Town of Brookfield
645 N. Janacek Road
Brookfield, WI 53045
(P) 262-796-3788
(F) 262-796-0339

Architectural Review Committee

AGENDA

TOWN OF BROOKFIELD ARCHITECTURAL REVIEW COMMITTEE STAFF REPORT

Graze Craze

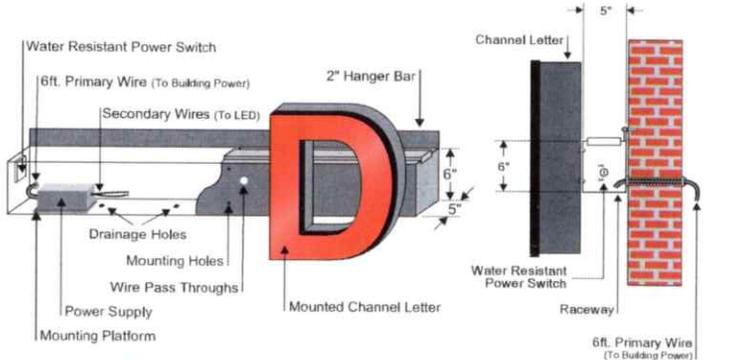
Proposed	Permitted	Waiver required?
Wall Sign	23.75 Sq. Ft. (130” x 28.5”)	11.6 sq. ft.	Yes , sign size

The frontage of the unit is very narrow at only 14 ft. 6 in., which would allow for an 11.6 sq. ft. sign. The applicant has submitted a second rendering that illustrates how the sign would look if it were to be 11 sq. ft. as permitted by code, which does appear to be out of scale with the building. Therefore, the applicant is requesting a sign size waiver.

The sign is proposed to go on one of the building’s peak and will share the space with a recently approved tenant, Vivo Infusions. Vivo’s building frontage was double the size as a corner unit and their approved sign is 22.125 sq. ft. An older google maps image below shows the building frontage with two signs on the wall peak. The proposed wall sign for Graze Craze is of similar size as Vivo’s installed sign.

I recommend **approval** of the proposed wall sign, including the requested waiver for sign size, for Graze Craze, located at 18900 W. Bluemound Road, Suite 139, as proposed on the plans with a revision date of January 15, 2026.

CIVIL SITE PLAN

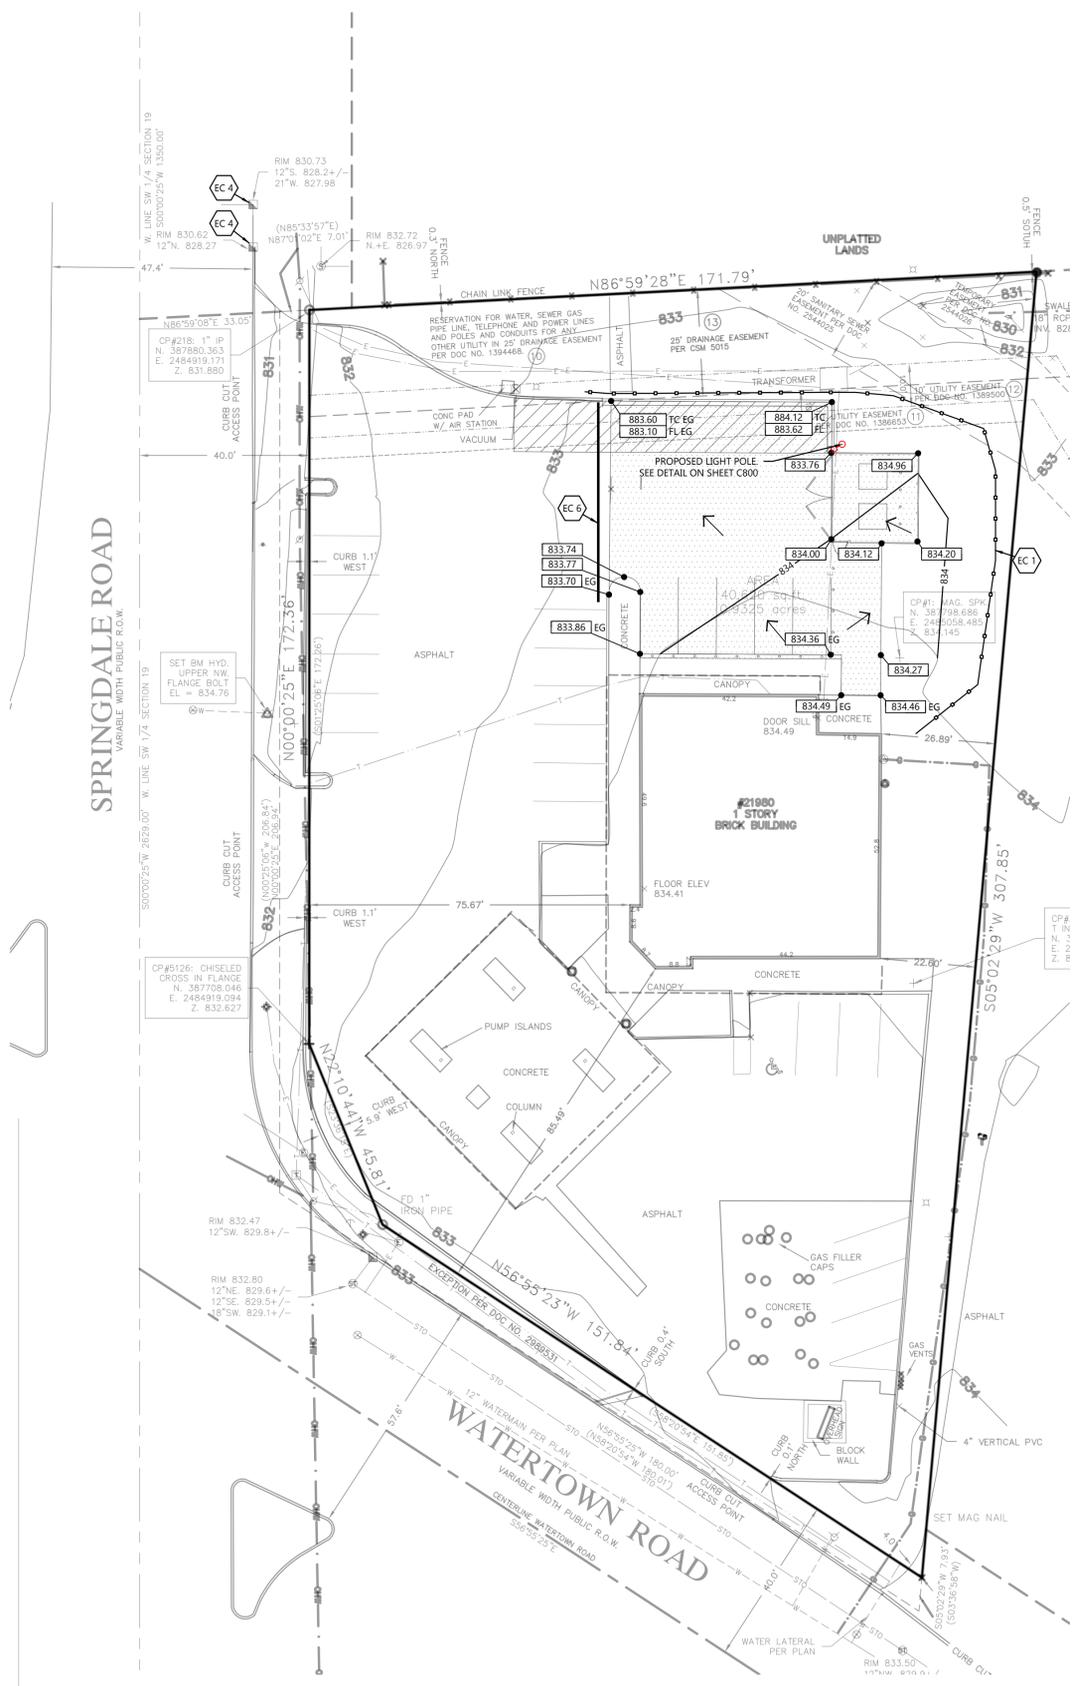
Parking: The parking lot expansion will result in a net gain of 2 spaces, and will bring the total parking stalls on site to 33 stalls, including 8 existing fuel stalls. One ADA-compliant parking stall is required on site and is provided for on the south side of the building (no change). The proposed stalls meet the locational requirements and the dimensional standards of the ordinance. Bollards will be placed at the front of the parking stalls between the building.

The Ordinance does require that landscaping be provided (at least 100 sq. ft.) for parking areas serving 5 or more vehicles and created or redesigned and rebuilding following adoption of the ordinance. However, given the site maneuverability on site, requiring landscaping within the parking lot would have the potential to create a traffic flow issue.

Dumpsters: The dumpsters are proposed to be relocated to the east of the parking lot expansion. The proposed concrete slab is 20'-9" x 21'-6" with 8 ft. tall fencing. The fence enclosure is constructed of solid-cellular vinyl for durability and low maintenance, but will be finished to look like wood. The Code requires that dumpsters meet the offset of the district and comply with the area requirements of an accessory building. The dumpsters are 22' from the west offset and the total square footage of the slab is 446 sq. ft., which larger than the existing dumpster area (approx. 237 sq. ft.). The maximum accessory building is limited to 625 sq. ft. Therefore, the size and location of the dumpsters meet the ordinance requirements.

I recommend Preliminary and Final **approval** to the Town Plan Commission and Town Board of the proposed site plan changes at 21980 Watertown Road for Kwik Trip, including an expanded parking lot, dumpster relocation and enclosure and lighting modifications, as shown on the civil plans dated February 18, 2026 and dumpster plans dated February 25, 2026, prepared by Excel Engineering, subject to any final Town Engineer comments being addressed.

Project Description

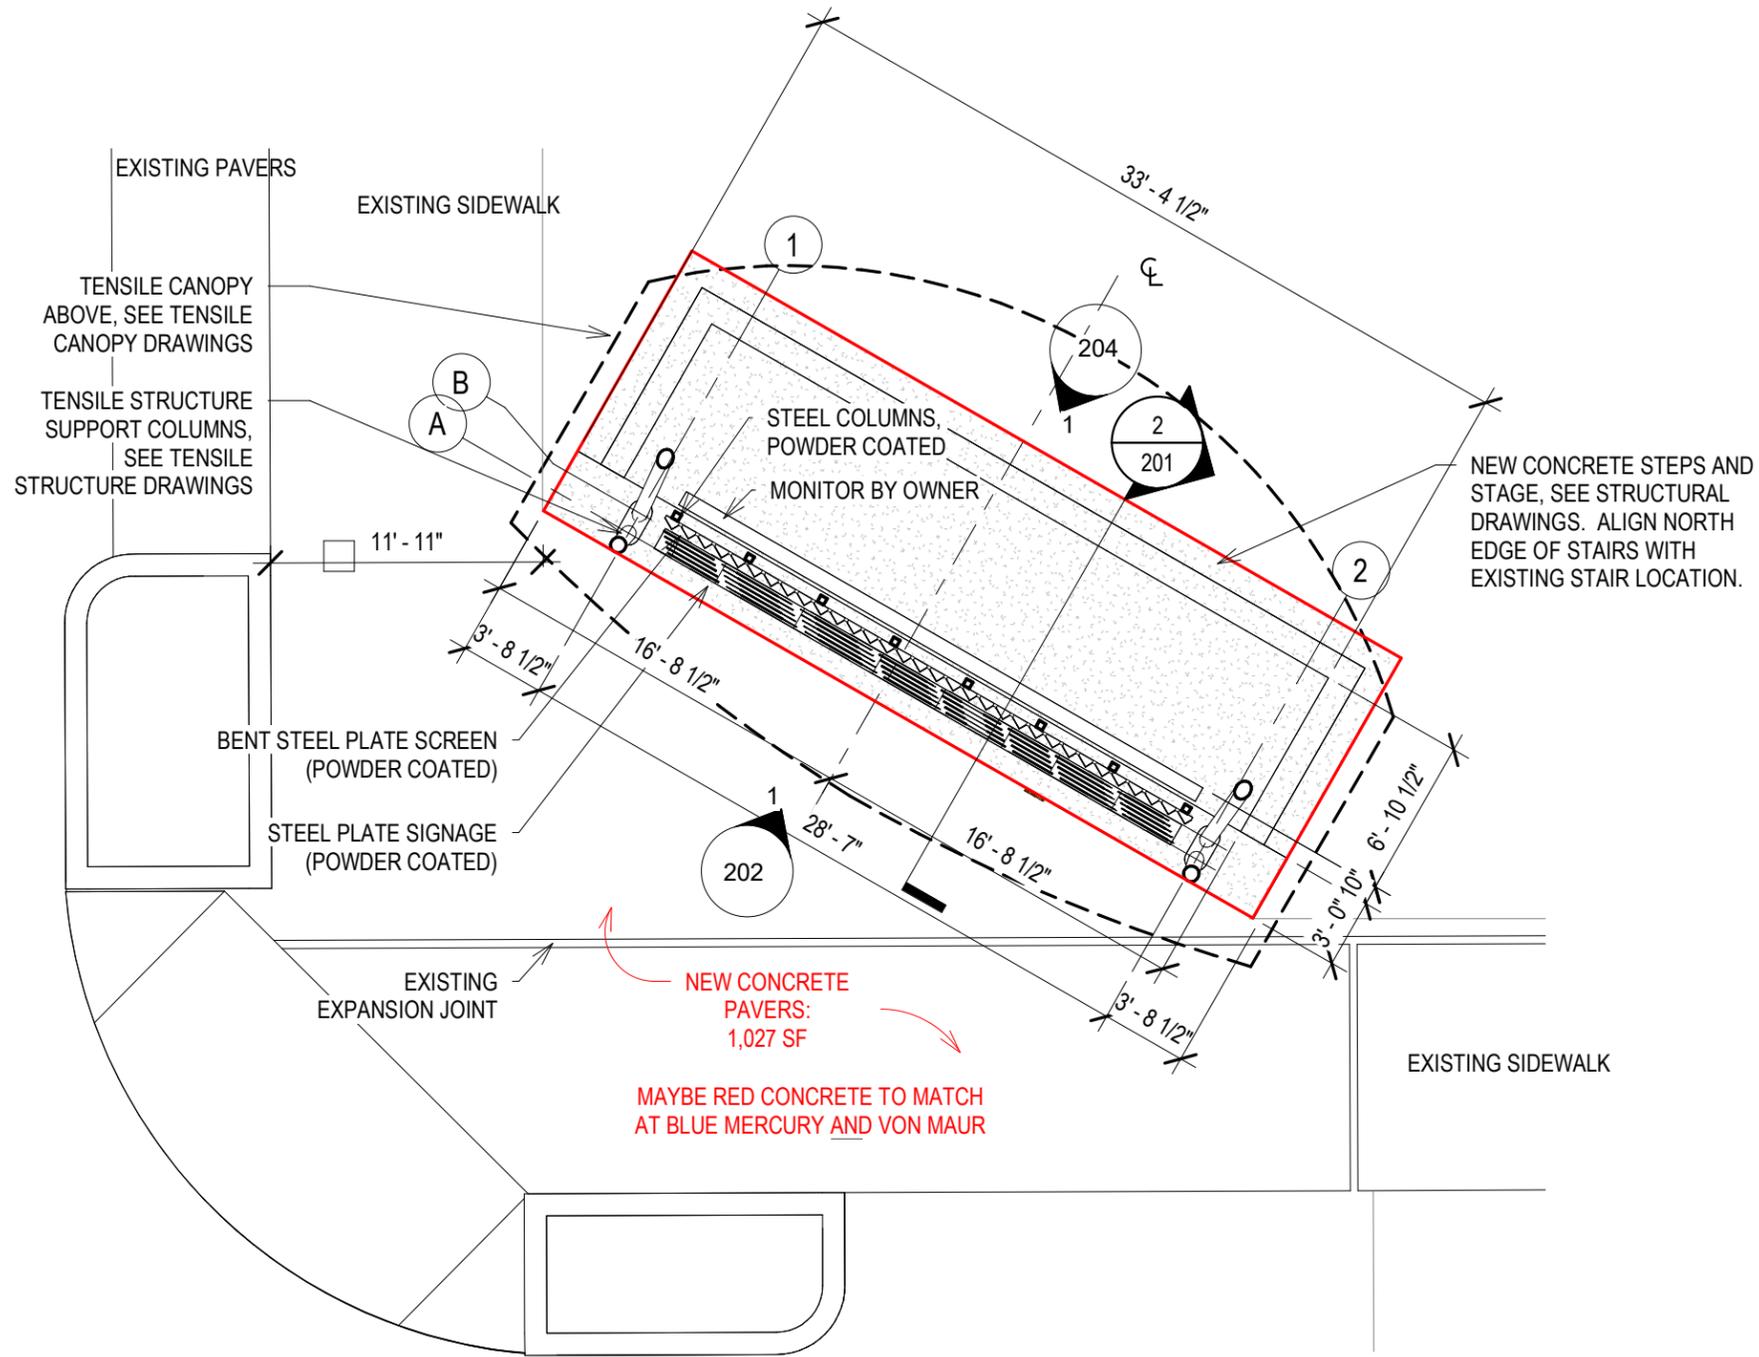
The Corners of Brookfield is proposing modifications to Market Square, which is the plaza space north of Von Maur. Market Square hosts a variety of events in this space and currently has an elevated 20 ft. wide LED-screen and open air stage in the southwest corner. The LED-screen is beginning to fail. In addition, a structural engineer discovered corrosion of the steel frame surrounding the LED-screen and mounting hardware. They also found significant cracking of the stage and integral planter that may be contributing to deterioration of the concrete structure below due to water migration. Therefore, the owners are proposing an enhanced stage and screen for Market Square.

The proposal includes a new stage, screen, increased waterproofing measures and new pavement. In addition, there is now an overhead protective canopy for the performers on stage and the screen. The primary color of the stage is white, with the south side incorporating colors from The Corners logo, including orange, red, teal and blue. The south side of the stage that faces Lord Street includes "The Corners" and "Town of Brookfield" signage, which will have up-lighting at night. The highest part of the canopy is 19 ft. tall as measured from grade. The stage is 6'-11" deep by 33'-4.6" long and is elevated 1'-7.6" with two stairs. New concrete pavers will surround the sides and rear of the stage to replace the sidewalk (1,027 sq. ft.). The landscape planter will be demolished and does not appear to be replaced.

The Architectural Committee may wish to discuss whether replacement of the planter box, or any landscaping, should be considered.

I recommend Preliminary and Final **approval** to the Town Plan Commission and Town Board for the proposed site plan changes to Market Square at The Corners of Brookfield as shown on the plans dated January 15, 2026, prepared by Dan Beyer Architects.
